**ADDENDUM NO. 2**

Notice to All Persons and Firms proposing to Submit a Bid or Furnish Materials for City of Maryland Heights **McKelvey Woods Trail Phase II Bid No. 2017-02 (Federal Project No. STP5401 (659))**

**MSE WALL**  
(NOT TO SCALE)  
(WALL 2B)

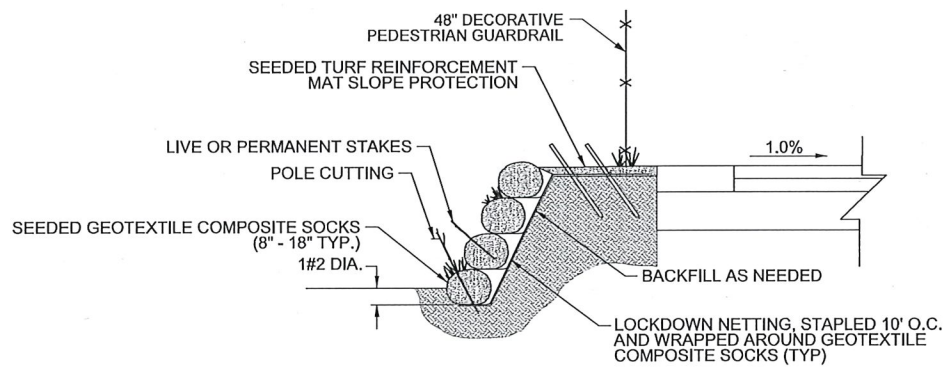
3. Sheet C-302 of the contract drawings shows a block wall. In JSP 59, Section 01.B states that the work includes installing a concrete MSE wall, Section 01.F provides the name of approved LIVING WALL SYSTEMS. Section 02 states MSE wall system shall be wire face. What is required, block wall, concrete wall, living wall or wire wall? Please provide a typical cross-section of the required wall. Please provide the limits of the planting mix that needs to be placed behind the wall face. What is the required design life of the required wall?

**Wall 2B (5 Degree Batter) is a MSE Wall System and shall be constructed using a Living Wall System. Section 01.B of JSP will be amended to reflect the design requirement by removing the word "Concrete". Sheet C-302 will be amended to note Wall 2B to be constructed using a MSE Wall System and remove the word "Block".**

**The limits of the planting mix needing to be placed behind the wall face shall be determined by the Wall Designer to facilitate plant life on the face of wall.**

**The required design life of the MSE Wall System shall follow requirements and guidance published by AASHTO and the Missouri Department of Transportation Specifications.**

MSE WALL #2B

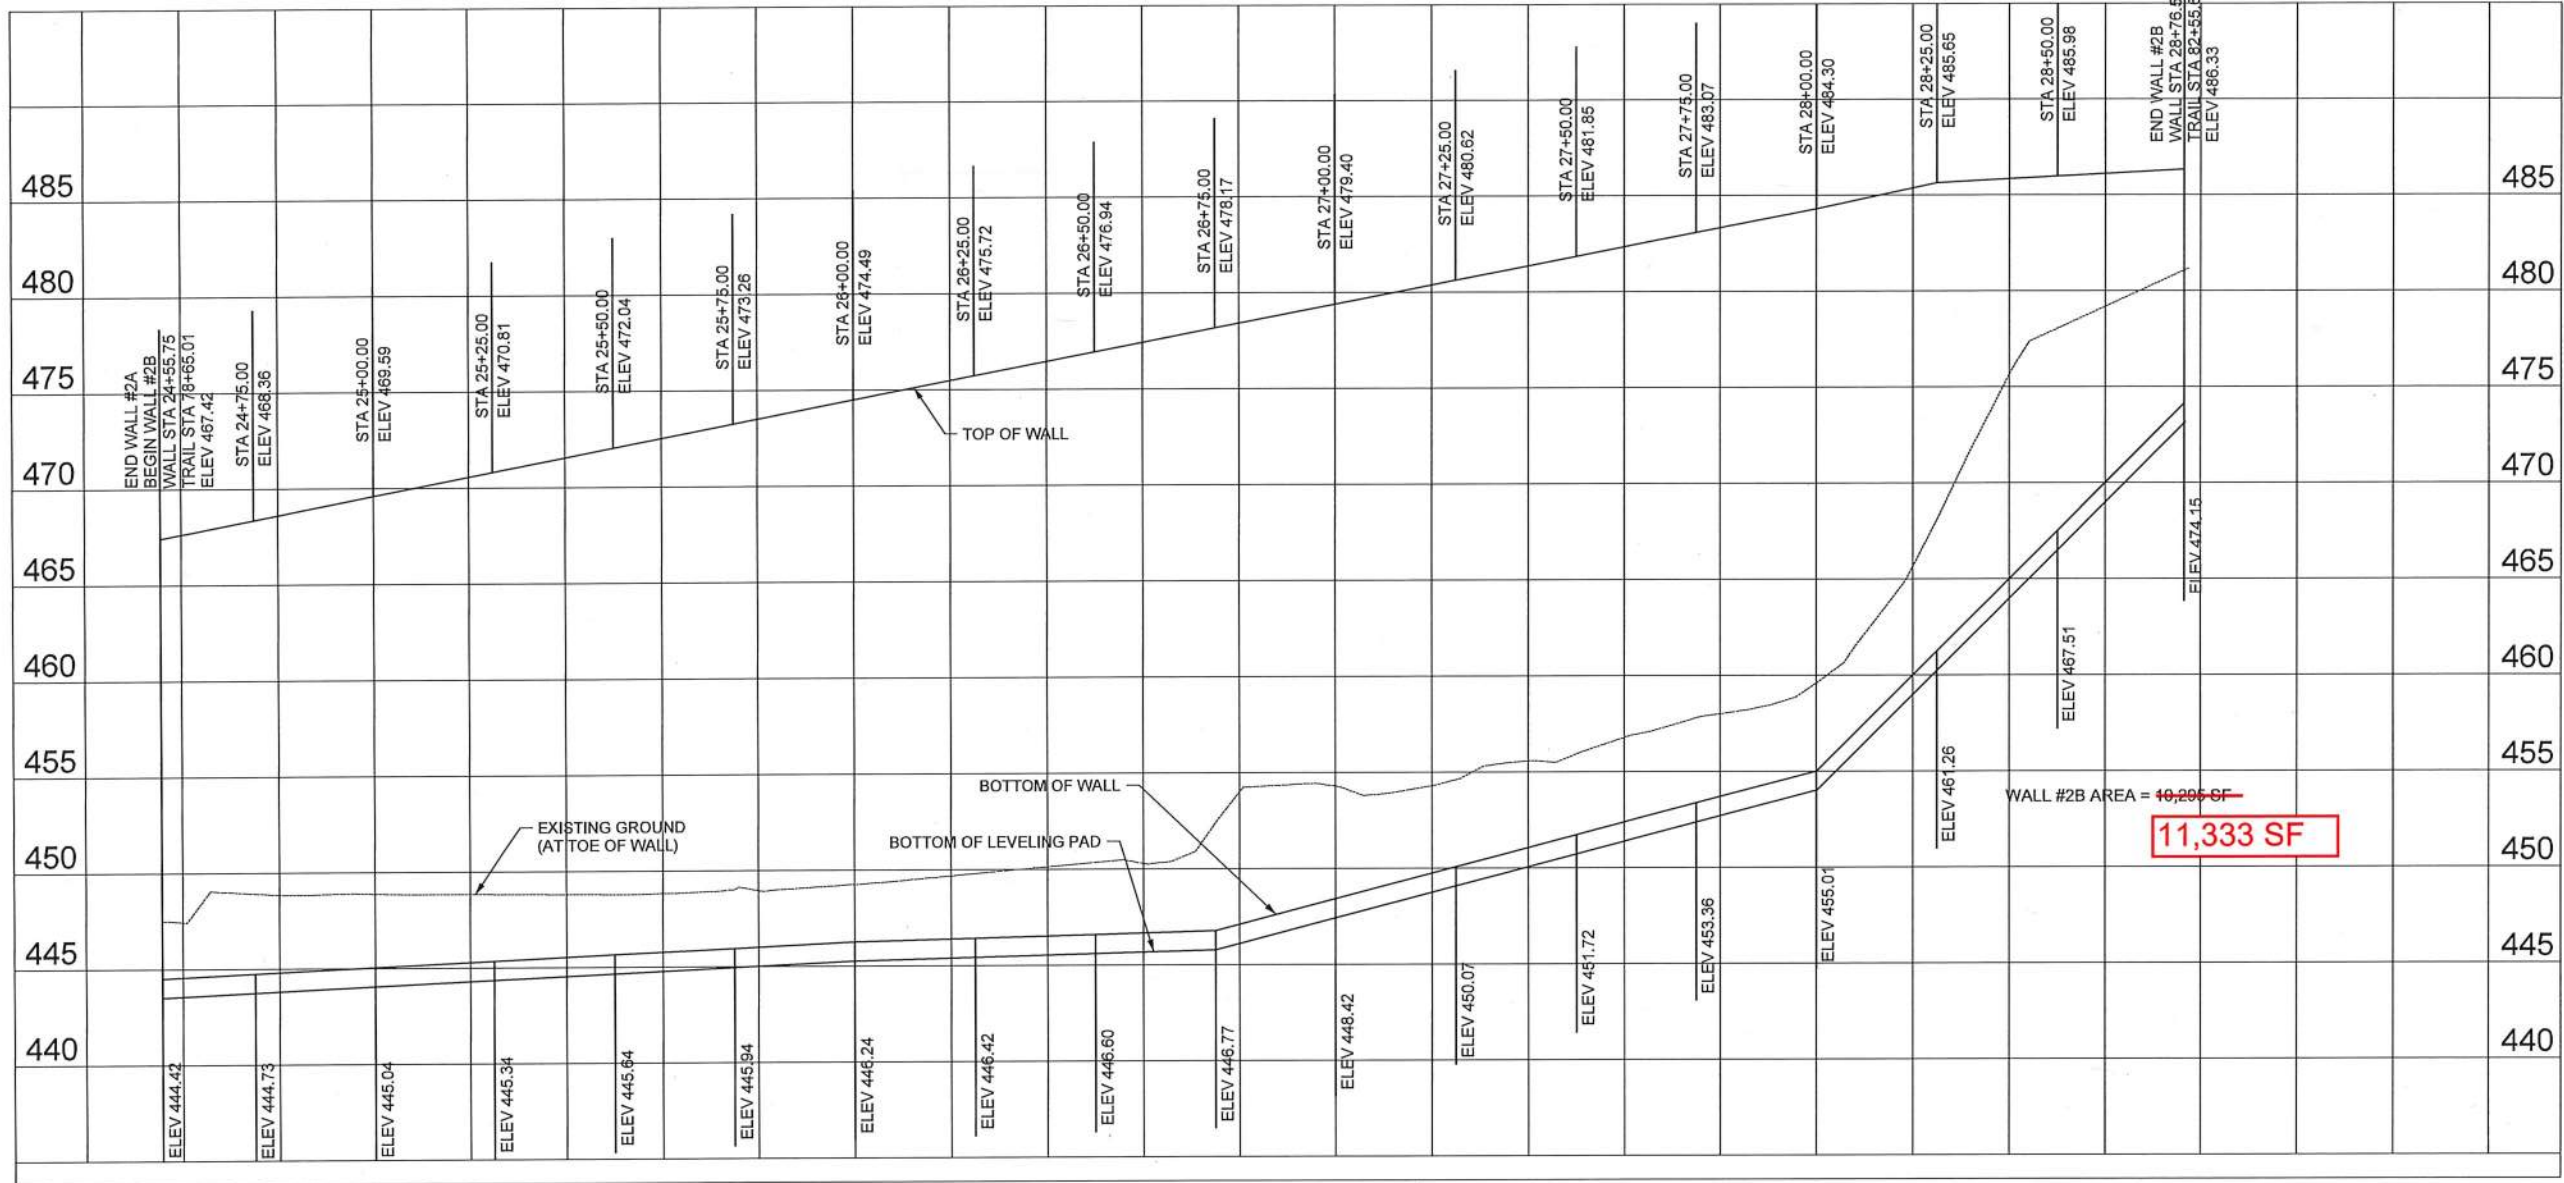
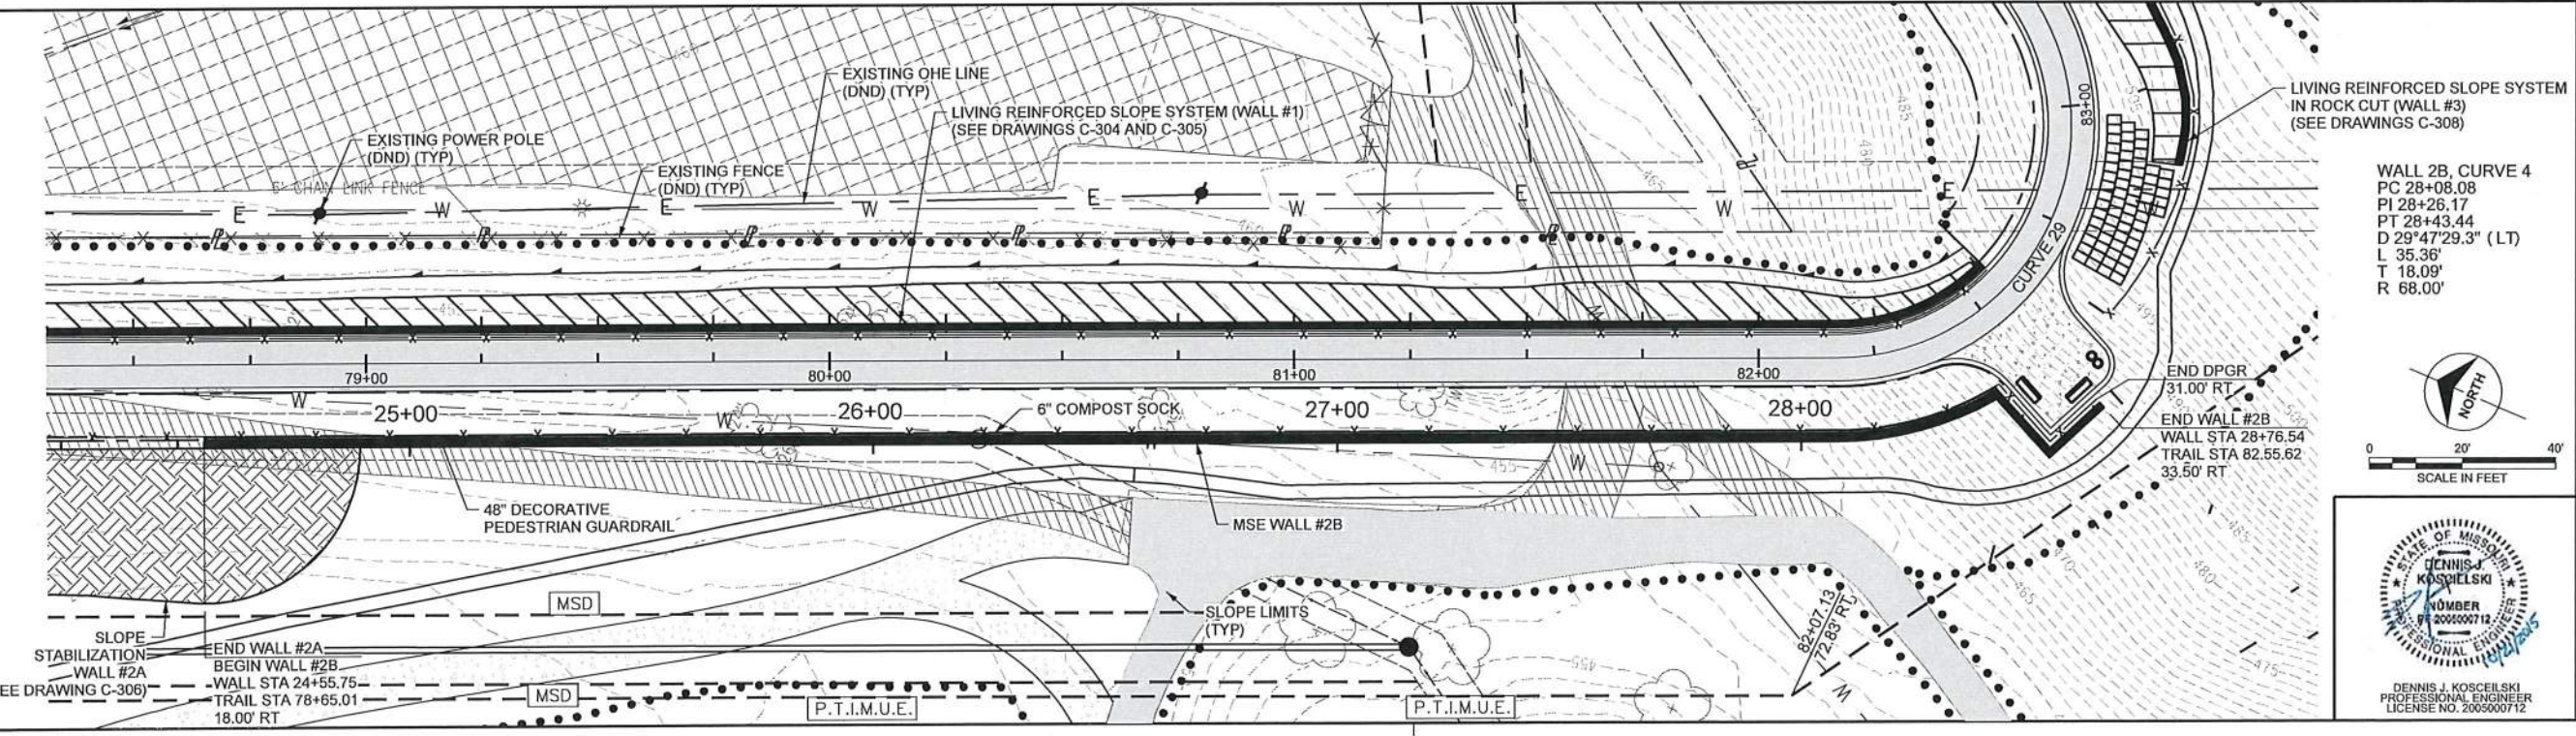
**The pay item is paid for total square foot of wall including unexposed wall face. Quantities are adjusted see attached 2B sheet, wall profiles and revised bid form.**
